• **BRAKES—LONGER THAN EXPECTED PEDAL TRAVEL WITHOUT ADDITIONAL PEDAL EFFORT—VEHICLES BUILT FROM 3/1/1999 THROUGH 8/9/1999 AND WITH V-6 ENGINE** • **BRAKES—REDUCED POWER BRAKE ASSIST—DURING RAPID, REPEATED BRAKE APPLICATIONS—HIGH ALTITUDE OPERATION—VEHICLES BUILT FROM 3/1/1999 THROUGH 8/9/1999 AND WITH V-6 ENGINE**	**Article No. 99-23-3**

LINCOLN: 2000 LS

Figure 1 - Article 99-23-3

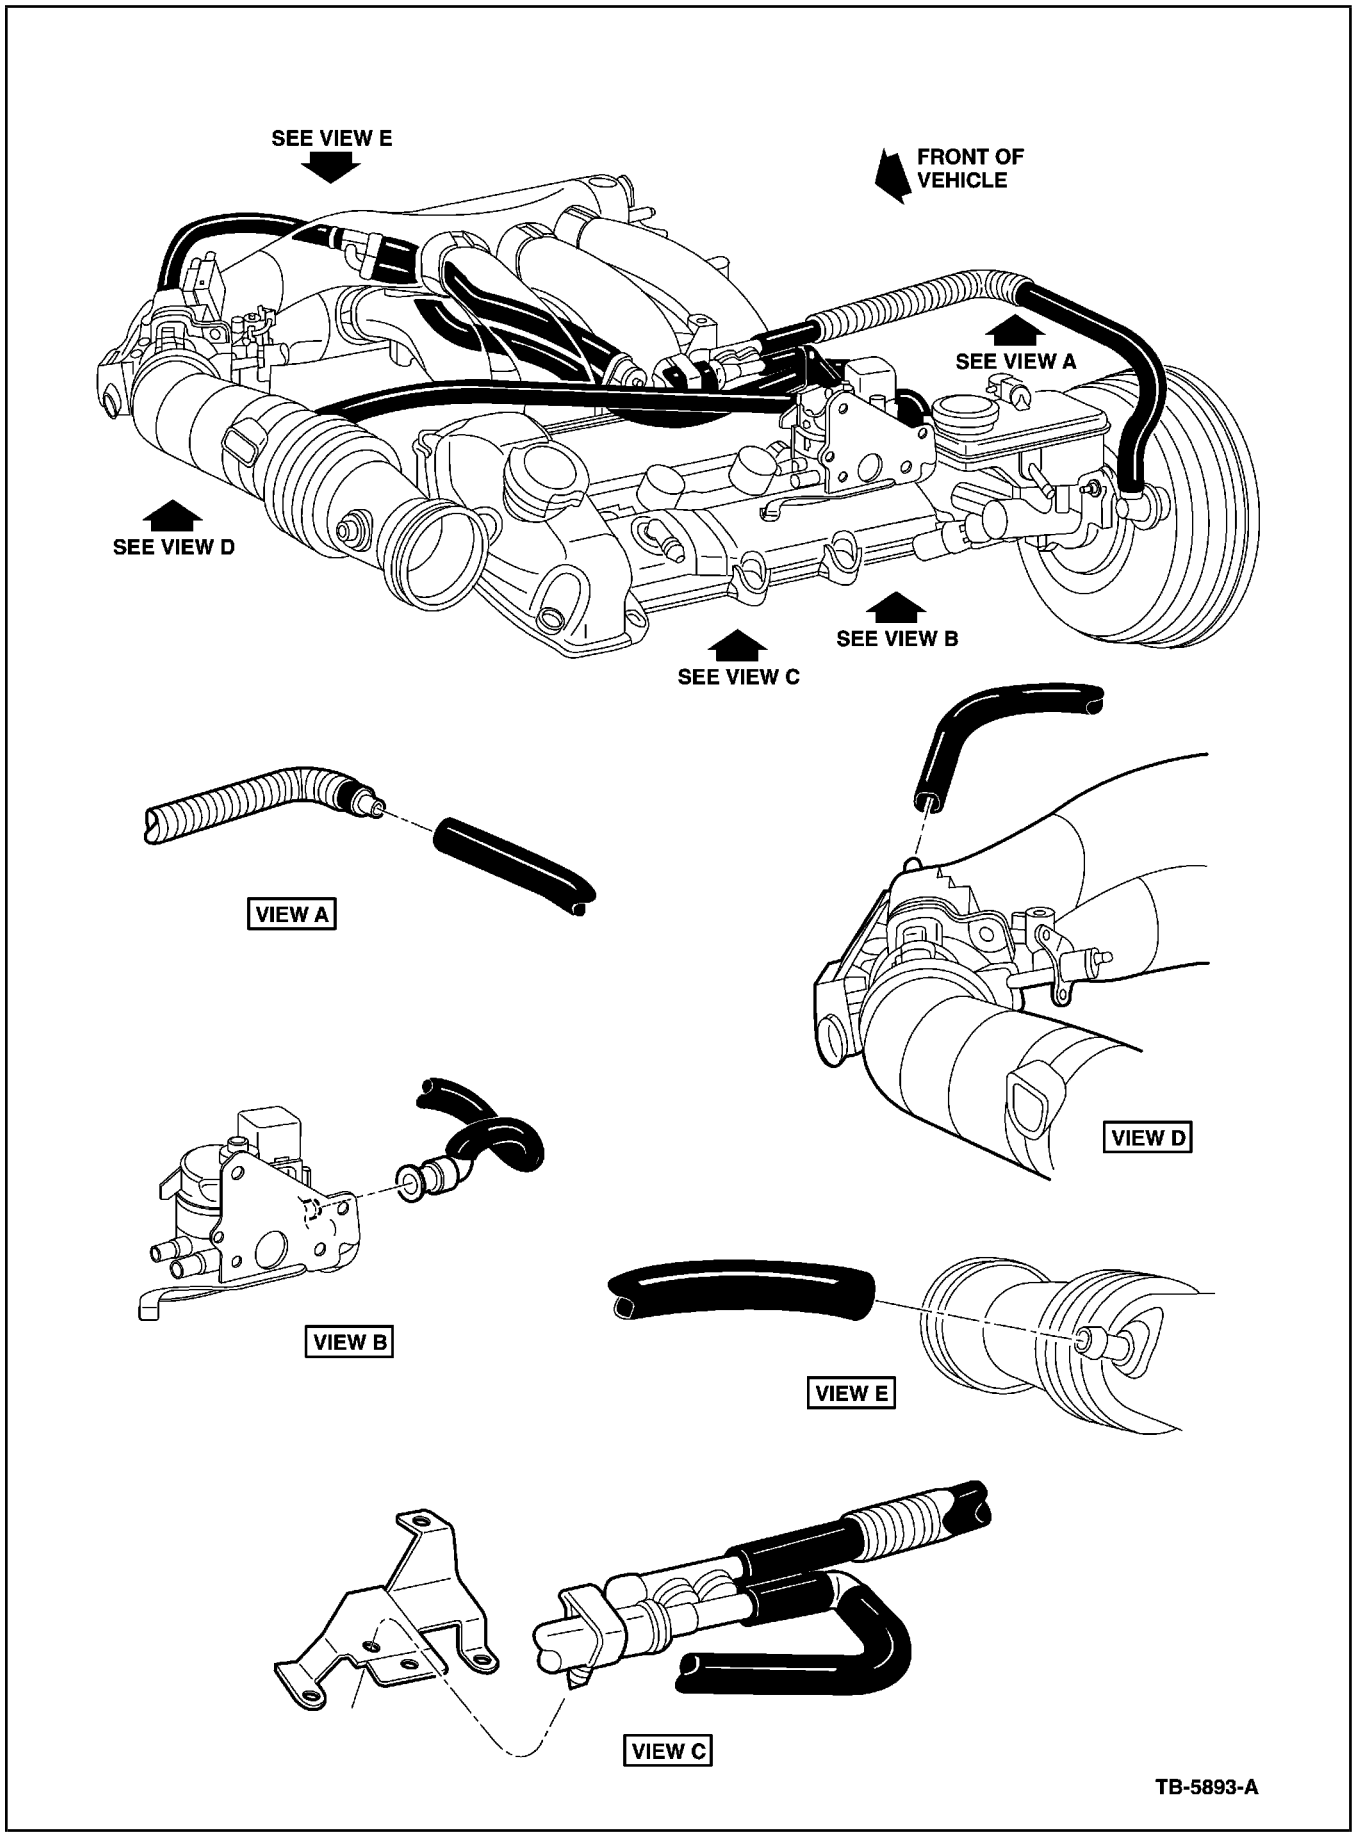
1. Connect the vacuum line to the brake booster in-line connector (Figure 1, View A).
2. Connect the vacuum line to the VMV (Figure 1, View B).
3. Connect the vacuum line to the air inlet tube (Figure 1, View E).
4. Route the vacuum line to the throttle body between the intake manifold runners and plenum and connect the vacuum line to the throttle body (Figure 1, View D and View F).
5. Insert the supply manifold assembly locator clip to the bracket on the engine (Figure 1, View C).
6. Verify that all vacuum lines are routed correctly and do not interfere with the throttle or speed control linkages.
7. Reinstall the engine appearance cover and VMV cover.
